BUCKHEAD ADDITION

WICHITA, SEDGWICK COUNTY, KANSAS

Re: 94-79 BUCKHEAD ADDITION (Final Plat)

CASE NUMBER: S/D 94-79 BUCKHEAD ADDITION

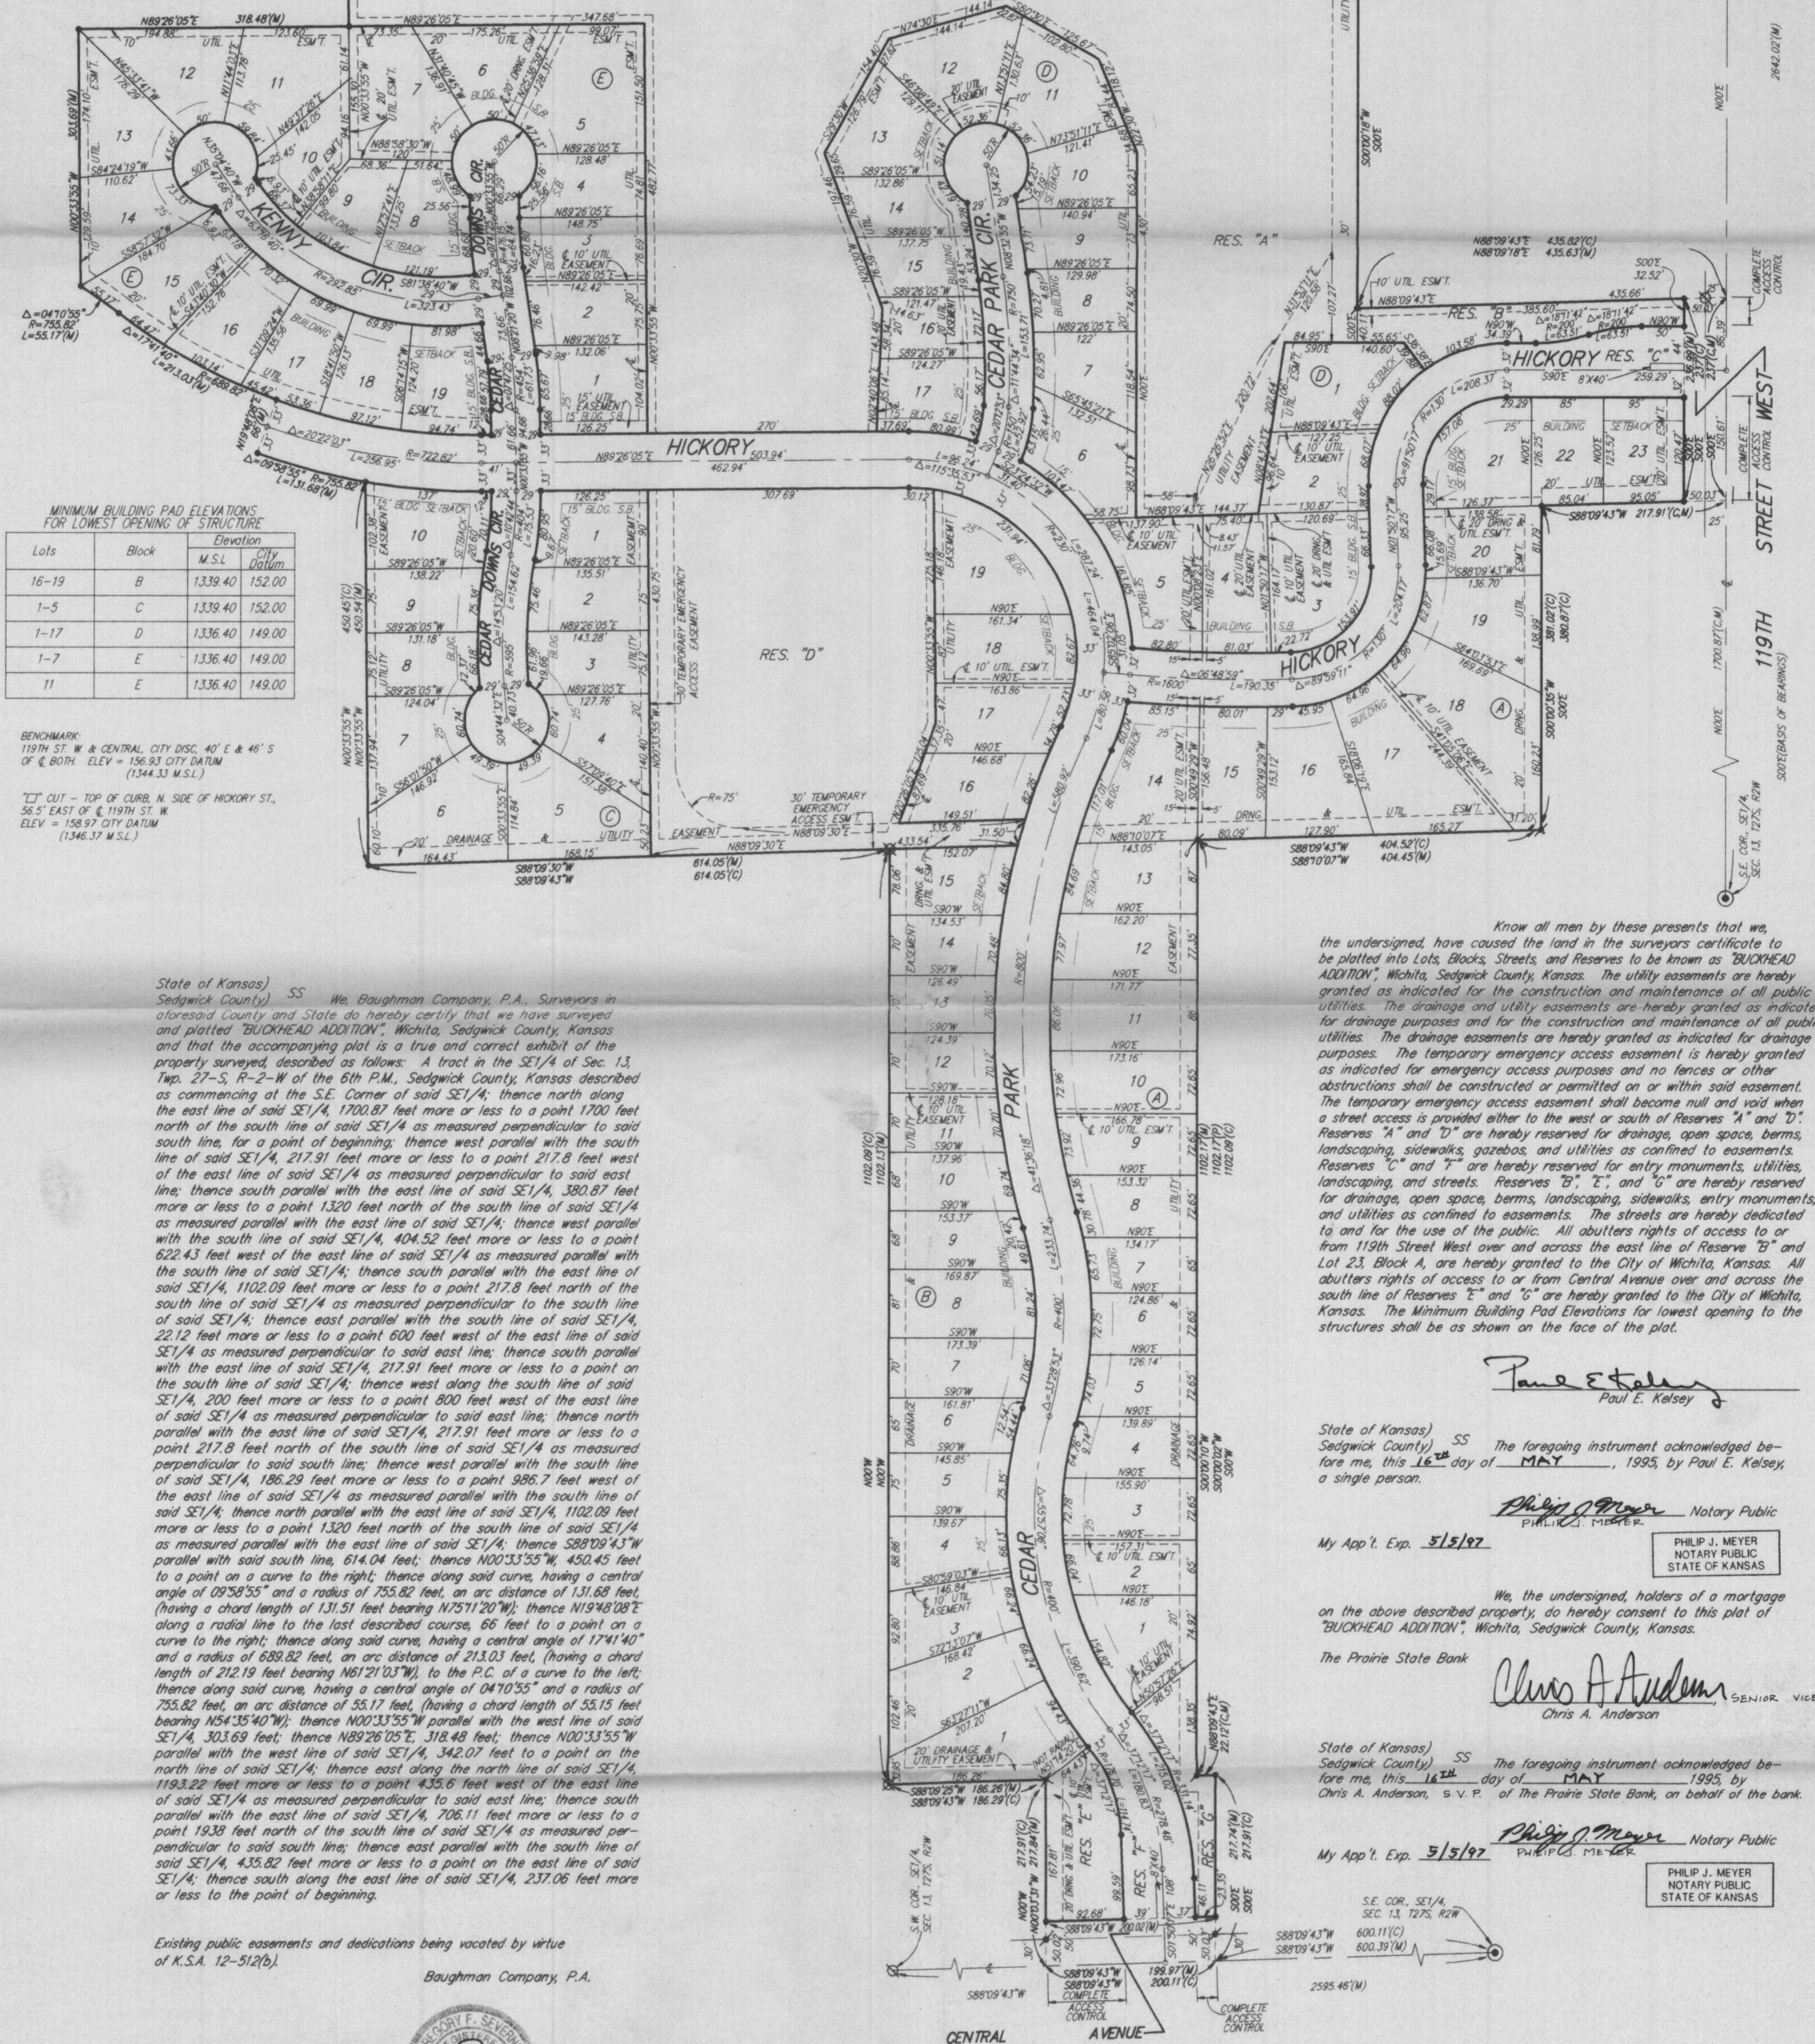
- D. The applicant shall guarantee the paving of the proposed interior streets. As indicated on the plat, Cedar Park/Hickory will require paving to the collector street status. In regard to sidewalks, the paving guarantees shall include a sidewalk on both sides of Cedar Park/Hickory (a collector), one side of Hickory as it extends out to 119th Street West and one side of the looped street Firefly-Birch-Bay Country.

cul-de-saced street. The two cul-de-saced streets noted as Cedar Down Ct. should for instance be named Circles. Also, this street should be called Cedar Downs, which agrees with the existing name in this area. In regard to Kenny, this street should be a circle.

L. In order to make the Reserves more accessible to the residents in the addition, it is recommended that additional access, such as an extension of the Reserves be provided in such locations as in the area of Lots 5 and 6 from Hickory to Reserve A.

M. For lots adjacent to the Lakes, the final plat tracing shall reference the required minimum building pad elevations in Mean Sea Level as well as City Datum. The platting of the minimum building pad elevation shall be noted on the face of the plat as well as in the plat's text.

N. Since this property is establishing minimum building pad elevations, the face of the plat shall reference the location and elevation of permanent on-site and off-site benchmarks. Section 5-402(N).

- T. On the final plat tracing, the plat's text shall be amended to note that streets are being dedicated to and for the use of the public.
- U. For Lots 1 & 2, Block D a 25-foot building setback to Hickory shall be platted.

- Z. The final plat shall indicate the utility easements requested by K.G. & E. Bell which is indicated on the enclosed "marked" copy of the plat.
